**DEPARTMENT OF TRANSPORTATION
STATE OF GEORGIA**

FILE: STP00-0003-00(623) Peach **OFFICE:** Engineering Services
P.I. No.: 0003623
SR 49 Drainage Improvements **DATE:** May 6, 2011

SUBJECT: IMPLEMENTATION OF VALUE ENGINEERING STUDY ALTERNATIVES

RE: STP00-0003-00(623)
Peach County
PI No. 0003623
VE Study Responses

PROJECT: Georgia Department of Transportation ALTERNATIVE NO.: **DR-7**
 STP00-0003-00(623) - PI No. 0003623 SR49
 South of CS629 to SR7 from SR49 to South of CS740

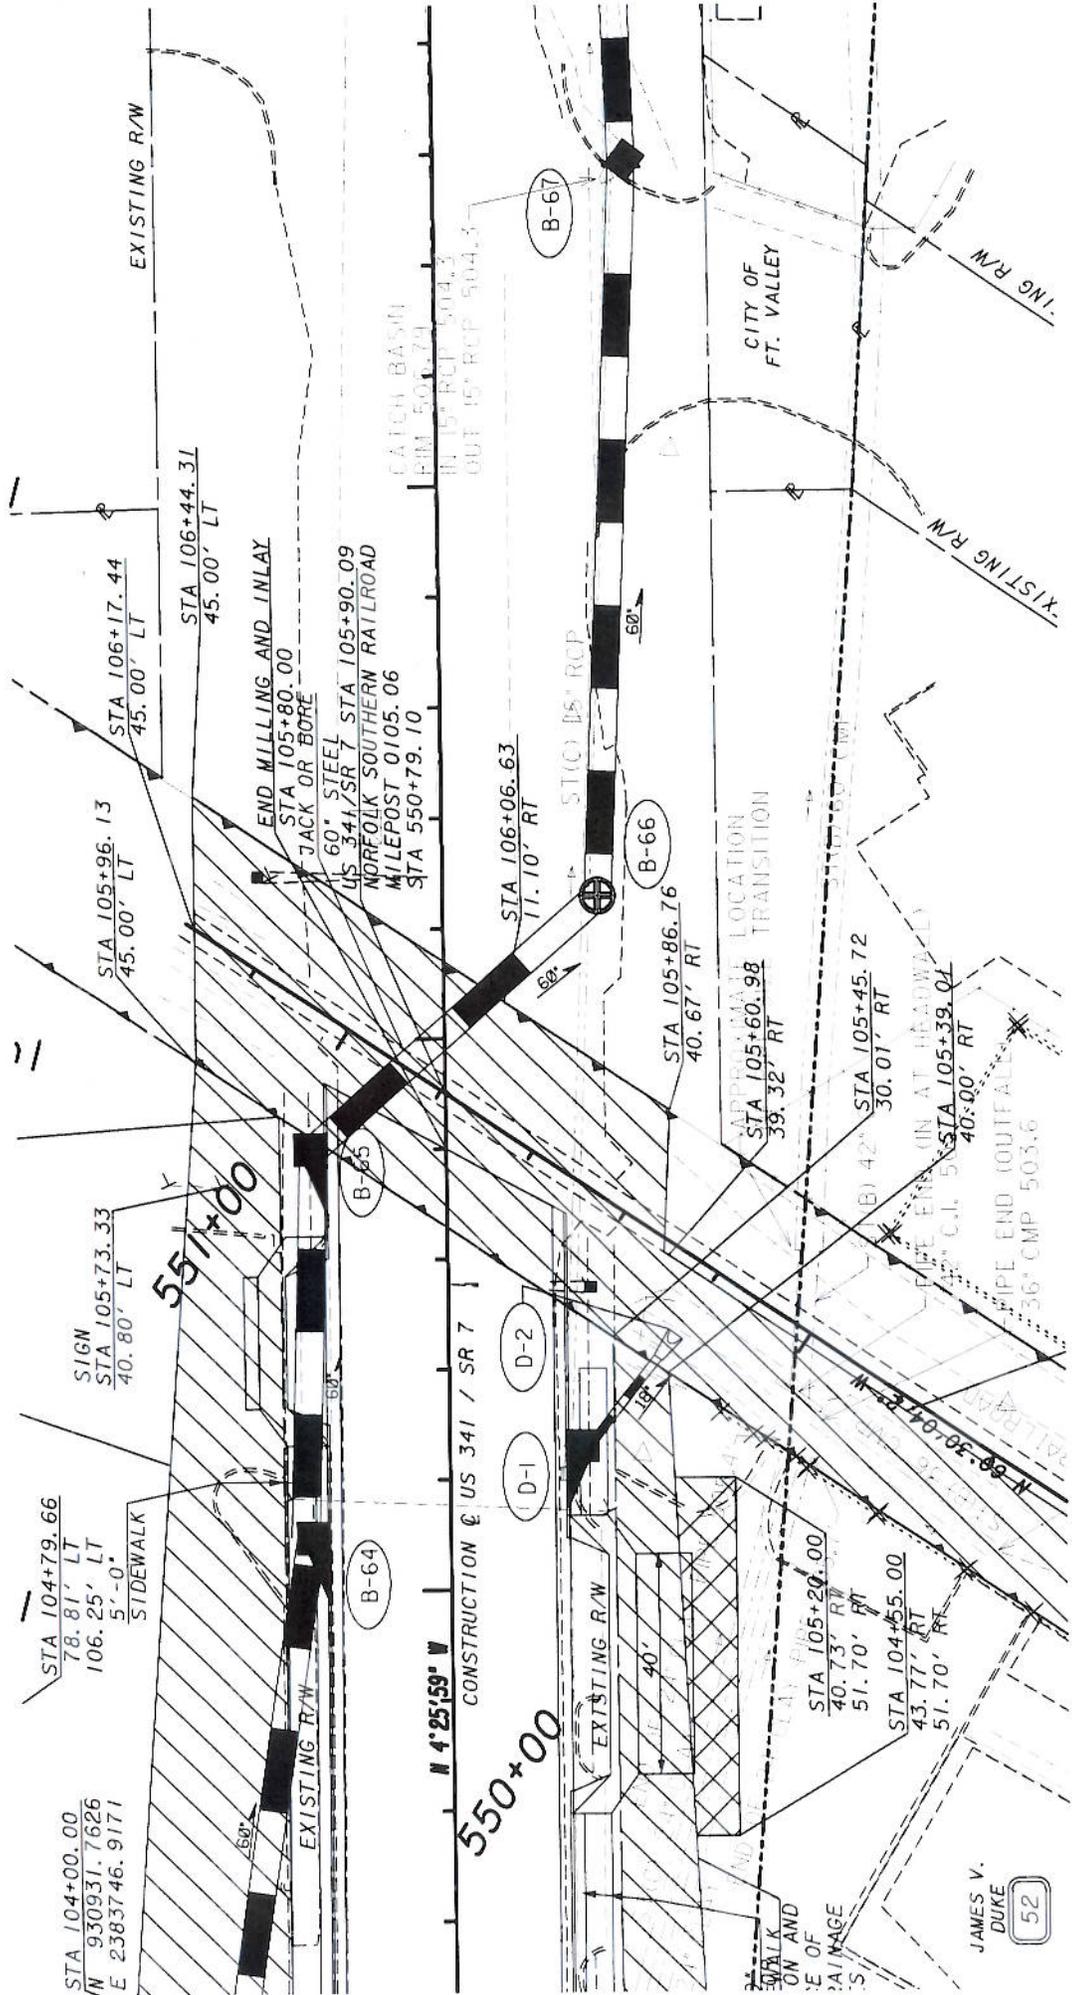
1. **Recommendation DR-7:** (Reduce length of jack or bore sections between B59 and B60)

Yes, will implement; however, the current layout has been modified from that proposed by the VE Study team resulting in a revised savings of \$ 49,309. This implementation is subject to railroad approval. Please see attached Sheets for layout and revised cost estimate.

ALT #	Description	Potential Savings/LCC	Implement	Comments
DR-7	Reduce the length of jack and bore sections between B59 and B60	Proposed = \$50,968 Actual = \$49,309	Yes, with modifications	This will be done; however, the layout has been modified from what was proposed by the VE Team. The modification resulted in a slightly smaller savings. This implementation is subject to railroad approval.
DR-8	Reduce the size of outfall from B60 to B66 by utilizing existing outfall	\$38,581	No	This has already been done with the System C drainage design. It currently reroutes water that should be flowing into System B. The amount of flow diverted to the existing outfall by way of System C is causing the existing pipe to flow at near capacity.
DR-9	Reroute C1 to C8 collection system to go through the B33 system	\$73,541	No	This recommendation would negate the use of the existing outfall and increase the size of the pipes in System B. Portions of the proposed savings would be realized by eliminating all road construction close to the intersection. The proposed construction limits must remain as shown in the plans to accommodate signing and marking and upgrading the signals

PROJECT:	Georgia Department of Transportation STP00-0003-00(623) - PI No. 0003623 SR49 South of CS629 to SR7 from SR49 to South of CS740	ALTERNATIVE NO.:	DR-13
DESCRIPTION:	Use two jack or bore sections in lieu of one from drainage structures A-41 to A-55

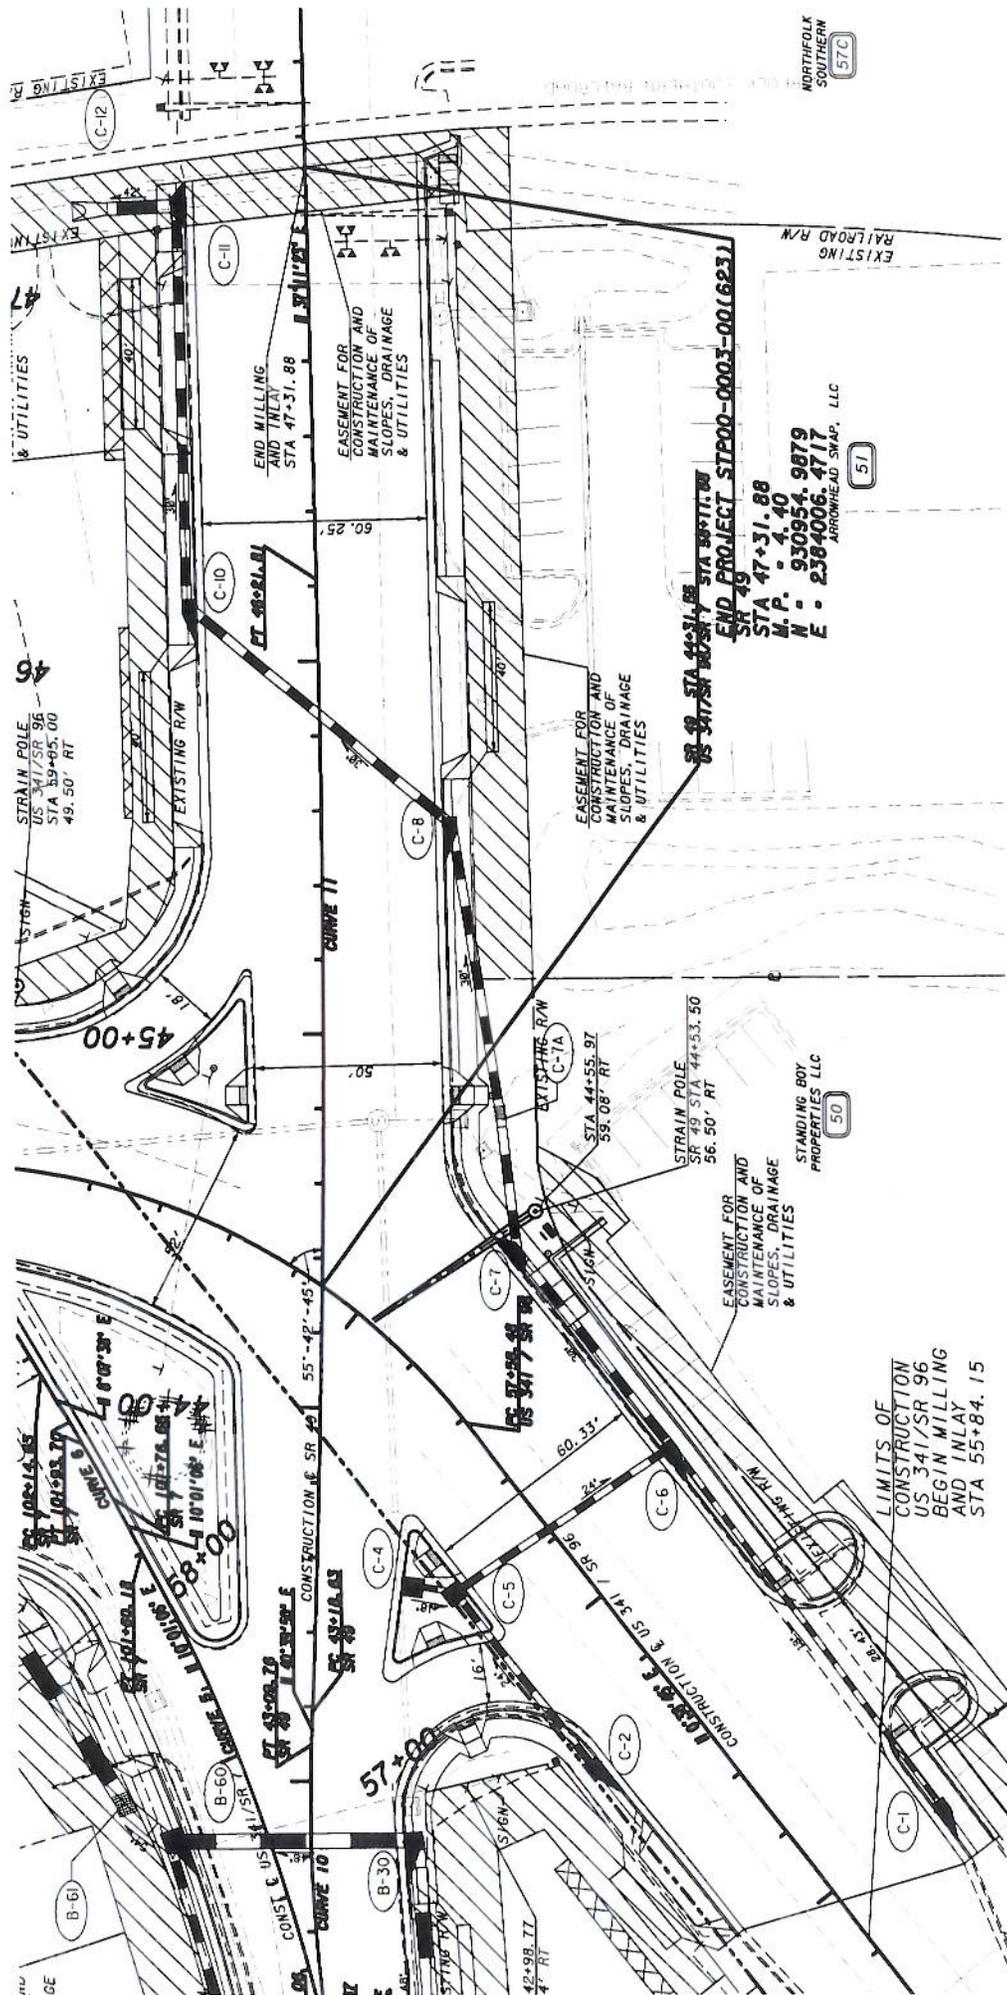
4. **Recommendation DR-13:** (Use two jack or bore sections in lieu of one from drainage structures A-41 to A-55)

Yes, will implement; however some of the lengths shown in the report on page 2-18 will have to be modified to keep the construction 25 feet from the centerline of the tracks. This results in two sections of jack or bore pipe totaling 167 LF, and an open cut section of 63 LF. This implementation is subject to railroad approval, but it does meet the requirements negotiated with Qwest Communications to avoid their utilities located on railroad property. This is the wording Qwest has requested be placed on our construction plans:

The actual savings will be \$ 33,261. The original spreadsheet had a \$30,800 error in the proposed cost as well.

PROJECT: Georgia Department of Transportation ALTERNATIVE NO.: **DR-14**
 STP00-0003-00(623) - PI No. 0003623
 SR49 South of CS629 to SR7 from SR49 to South of CS740

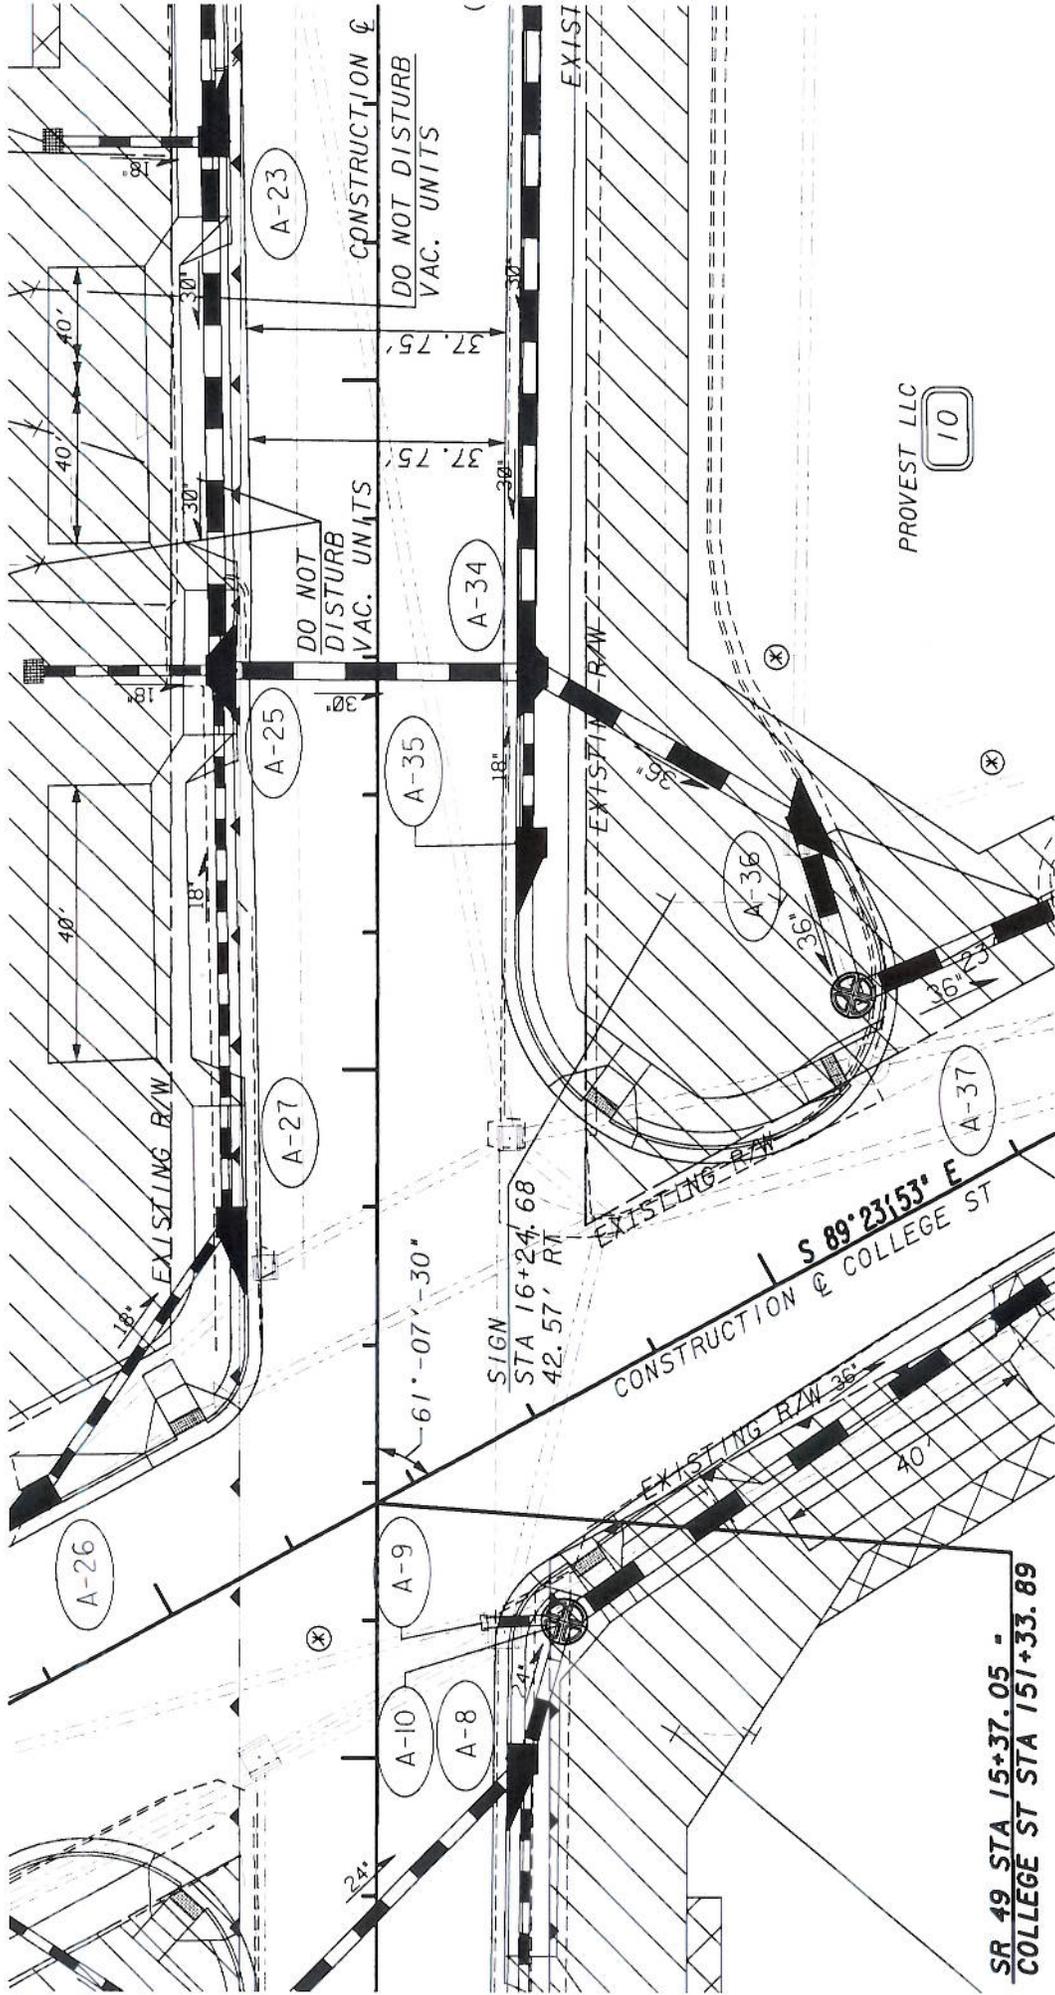
5. **Recommendation DR-14:** (Eliminate piping in selective areas)

Site 2 - Yes, will implement. Some the proposed 30" pipe shown on sheet 2-23 will actually be 36" pipe; however, the proposed option still costs \$6,552.77 less than the existing layout. Please see attached sheets for layout and revised cost estimate.

Site 3 – No, will not implement. This option will reduce the length of 18 inch pipe by about 55 LF but will result in an increased pipe size from structure A-31 to A-35. This means the layout as currently

DR-14	Eliminate piping in selective areas	Proposed = \$30,633 Actual = \$6,553	Yes, partially (Site 2)	<p>Site 1 – This recommendation would reduce some storm drain pipe length, but increase the required length of sanitary sewer pipe and add three sewer man holes.</p> <p>Site 2 – Some of the proposed 30" pipe shown on page 2-23 of the VE Report will actually be 36" pipe; however, since the proposed recommendation still provides a small savings, it will be implemented at this site.</p> <p>Site 3 – This recommendation would reduce the length of 18" pipe, but would result in an increased pipe size from structure A-31 to A-35; therefore, the proposed design is more economical.</p>
